**TECHNICAL ASSISTANCE TO THE
U.S. ENVIRONMENTAL PROTECTION AGENCY
ON 40 CFR PART 191**

U.S. Department of Energy

May 11, 1992

We are enclosing preliminary results on the tasks requested by EPA on January 7, 1992, to provide technical assistance related to the repromulgation of EPA's standard for disposal of high-level and transuranic radioactive waste, 40 CFR Part 191. This information is provided to you as part of the process of EPA's staff working with us as the evaluations proceed.

Figure 4-1. Containment Requirements in the Three-Bucket Approach

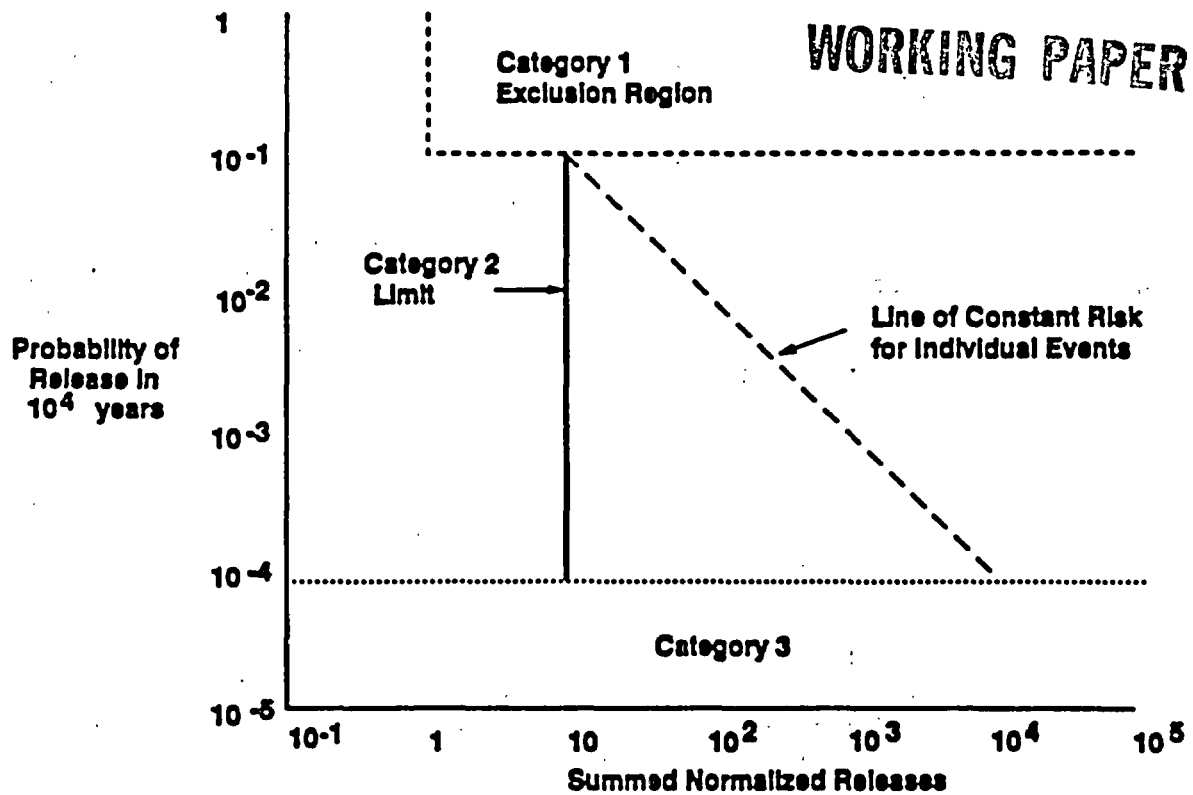
Another problem is the nonuniformity of category 2. As can be seen in Figure 4-1, the proposed requirement is 1,000 times as restrictive for events with probabilities of 0.0001 as for events with probabilities of 0.1. This nonuniformity could be eliminated by using the line of constant risk in Figure 4-1 as the category 2 limit. The accuracy requirements for probability estimates would then be uniform for the entire category.
